Site Instruction

Project Name: AQUAVISTA - Bayside
Client: TRIDEL Corporation
To: TRIDEL Corporation
Attention: Chadi Loza
Fax number: -

Project No.: 8489D
SI No.: E 006
Page No.: 1 of 1+ 3 Attached
Office: Toronto
From: Sunanda Perera

Title: EV Charging Stations/ Security conduit requirement.

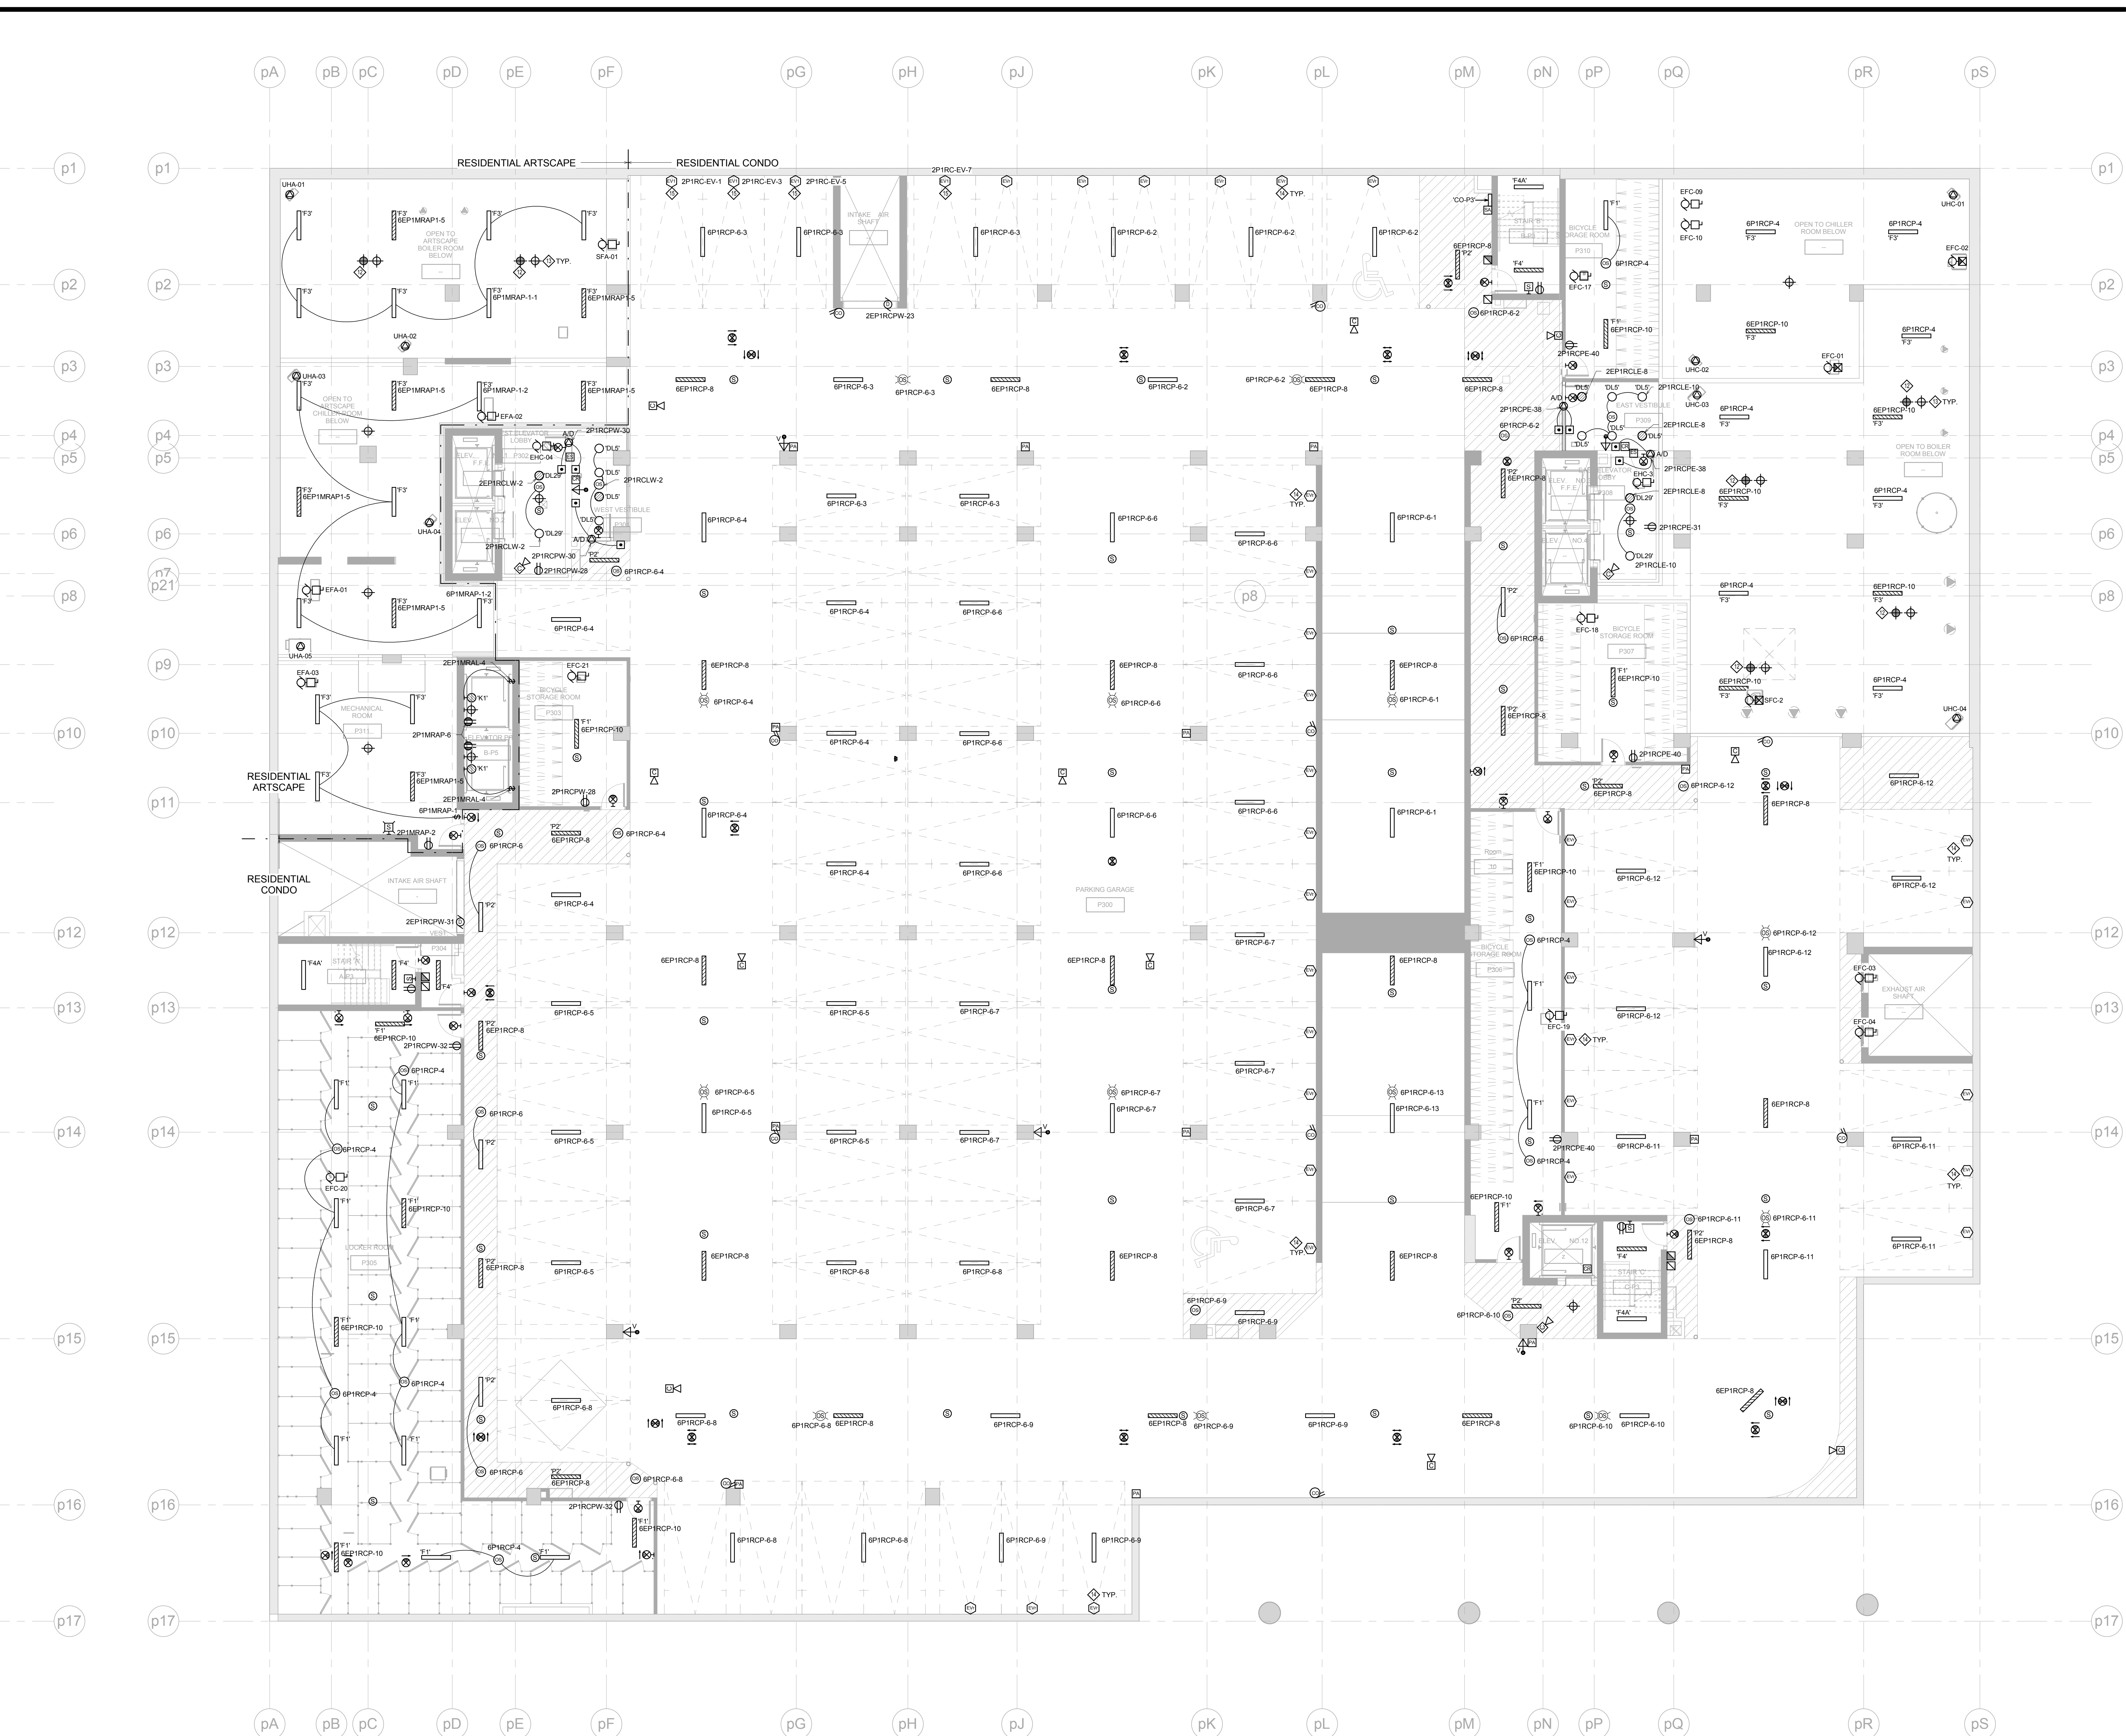
Drawing No.	Drawing Issued	Items
E1-01	Yes	P4 Level- Add EV rough ins (Qty-9) as shown.
E1-02	Yes	P3 Level-Delete EV rough ins (Qty-4) as shown.
E4-06	Yes	Add conduits for the sumps high float alarms.
